A COMPANY OF THE SWATCH GROUP	Product Change Notification PCN	Nr. 180312-20 Publishing Date: March 21 st , 2018
---	--	--

Product information			
Item affected / Type	Tray for Holder SMTU1225-LF		
Part - Nr. (SAP)	701115	Drawing-Nr.	n/a

Foam tray change to PS tray SMTU/HU holder series

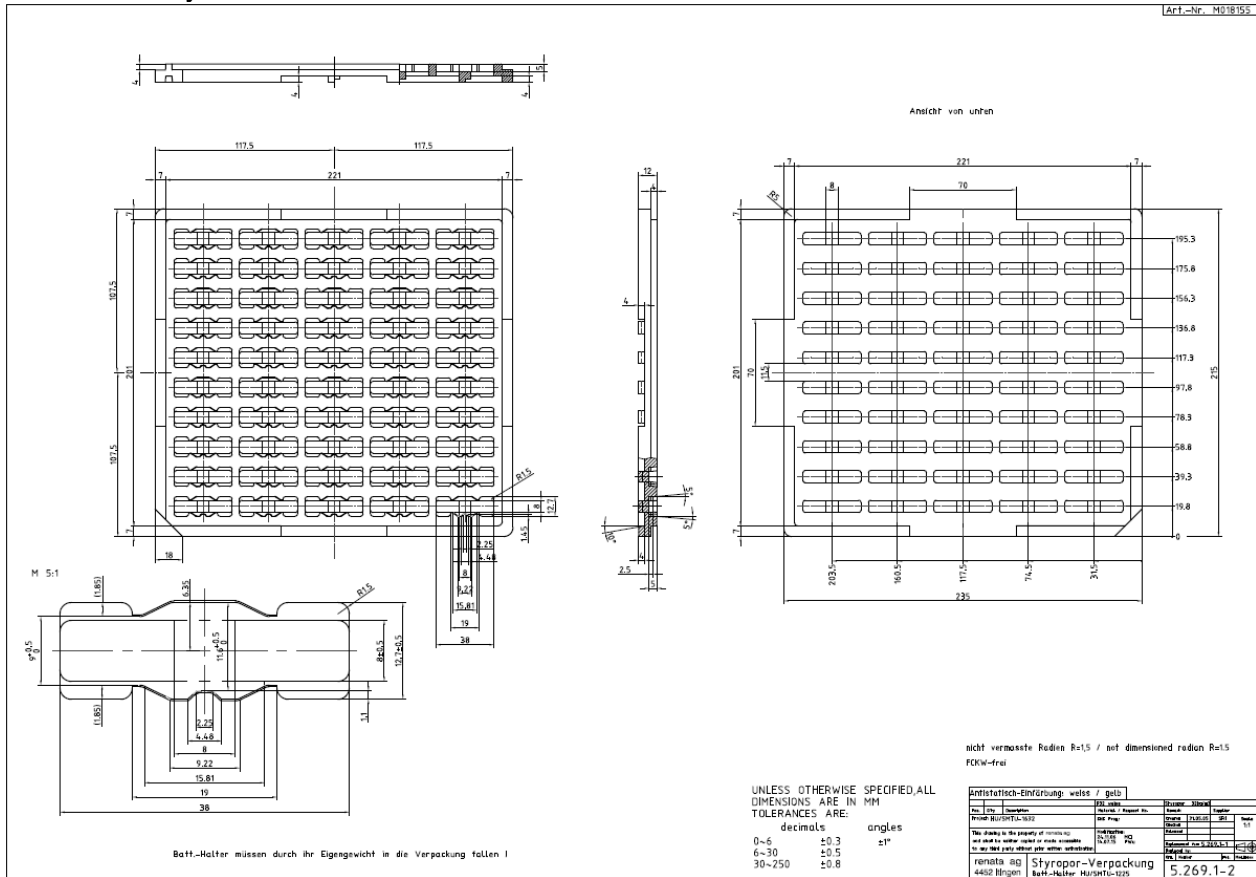
Product Change Notification	Description and reason of change
	Replacement of existing foam trays with PS (Polystyrene) material trays Drawing no. of Foam tray 5.269.1-2 Drawing no. of PS tray 5.436.2- Both drawing in attachment to compare. Same functions as PS tray Antistatic value: $10^3 \sim 10^6$ Quantities per Tray and also per shrinked pack will be kept unchanged. Placing of holders within in tray will remain unchanged Height of unit packing will be different. Current height for unit package foam tray: 98mm Estimate height for unit package PS trays 115mm Manufacturer part number will remain unchanged Change will be controlled by Lot number. Rolling change expected. Rollout of old tray expected to start in April 2018
